Batch 1: the building's changes

The Architect, 13 October 2026, for Godric. The ledger's lines 1 to 4 (docs/architect/changes.md); the castle model, version 14; question 14; 1:150 at A3. Red: what changes.

Plan at the seventh floor: her corridor, its landing and the bay

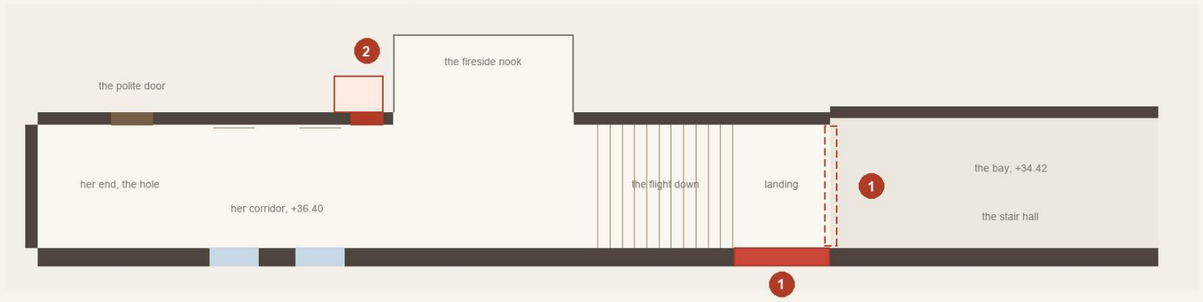
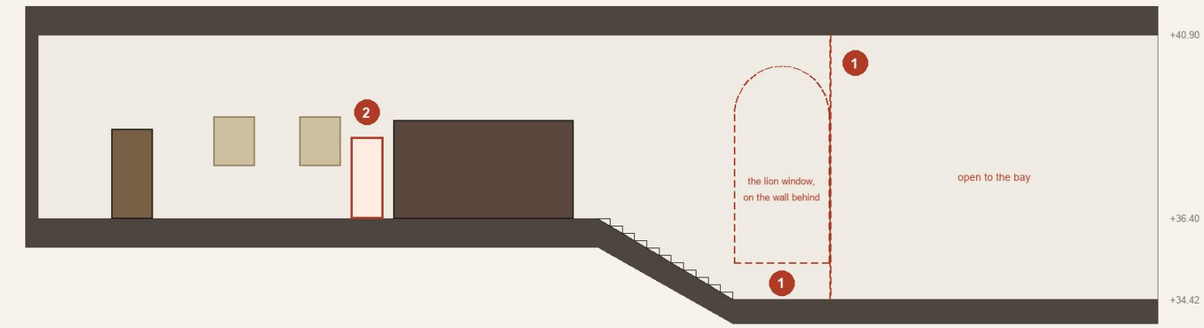
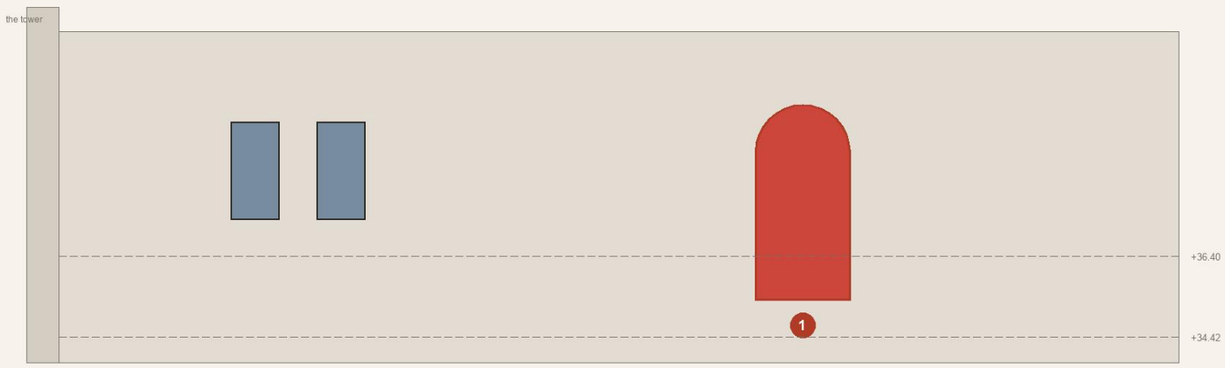
1 Her landing's far end open to the bay, no end wall; the lion window (2.33 by 4.8) on the landing's south wall, centred on it, its sill 0.9 above the landing (+35.32); the outer wall runs on along the flight and the bay, so its jambs stand in whole wall. Placed, model 14.

Plan of the Entrance Hall at the flags: question 14, the broom cupboard's place (line 3)

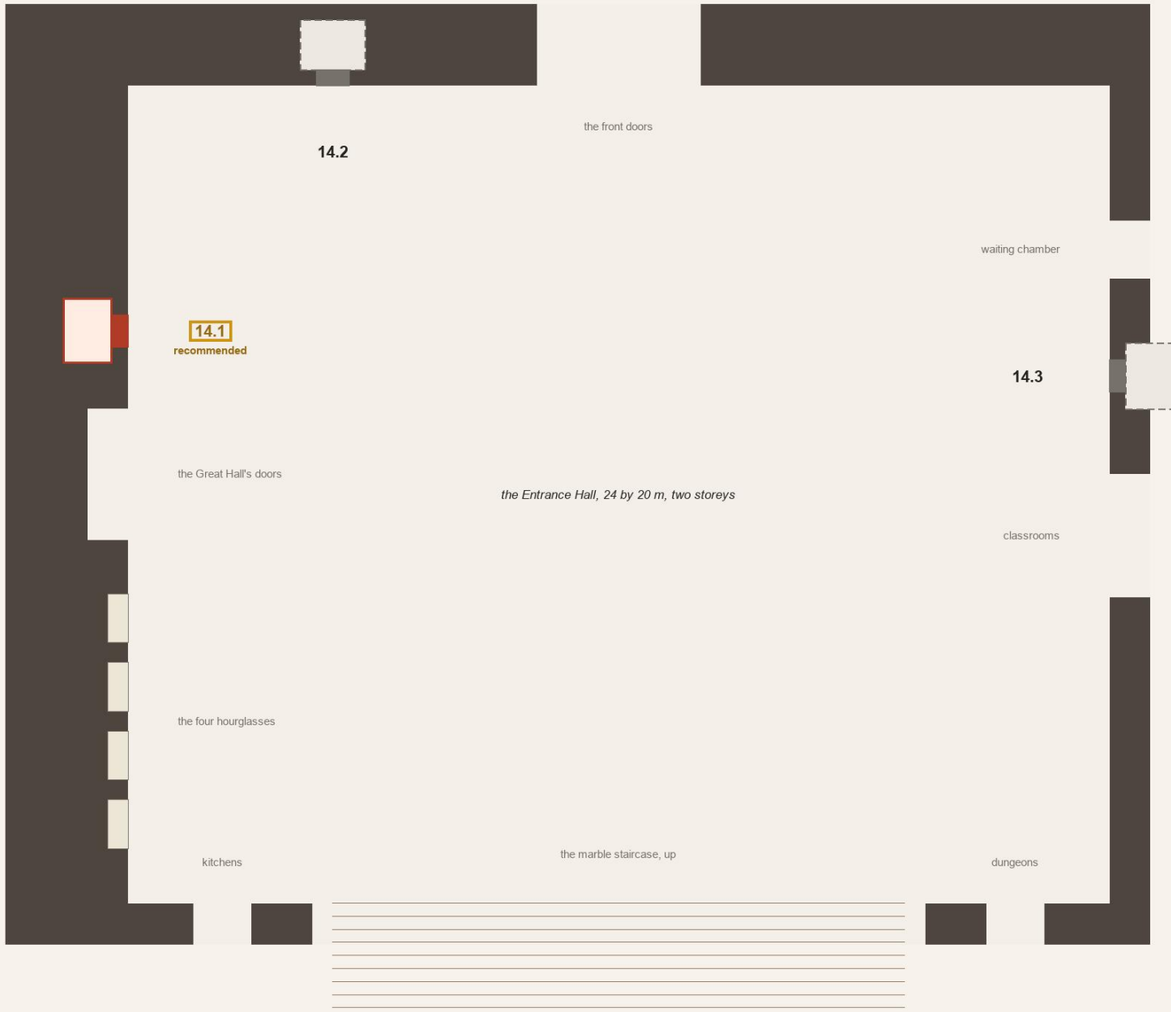
Question 14 (PoA 21: "dragged him across the hall to the door of a broom cupboard", "amongst the buckets and mops"; she hears them cross the hall and go "down the front steps"; Hermione sits on an upturned bucket)

14.1 the west wall, north of the Great Hall's doors. In the 3 m of wall between the two halls: no room loses ground and the front stays whole; the mops are needed after every meal next door. Across the hall from the front doors' sunlight. 13.4 m to the front doors; 1.50 m to the nearest opening (great-hall-doors).

14.2 the front wall, west of the front doors. Nearest the front steps (7 m). Lost: cut into the castle's front wall, 0.4 m of it left outside. 7.0 m to the front doors; 4.60 m to the nearest opening (front-doors).

14.3 the east wall, between the classrooms' arch and the chamber. Lost: three doors in 7 m of one wall, and it takes ground from the chamber or the classrooms' corridor, neither in the model yet. 13.9 m to the front doors; 2.00 m to the nearest opening (classrooms-mouth).

14.1's wall from inside the hall, looking west (south on the left)

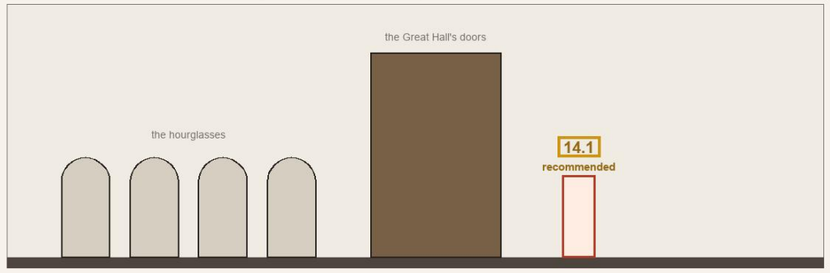
2 The broom cupboard's door, 0.8 by 2.0, 0.25 m clear of the second portrait and of the nook; the cupboard 1.2 along her wall by 0.9 deep, its door at its nook end, 0.25 m of wall left to the nook. Placed, model 14.
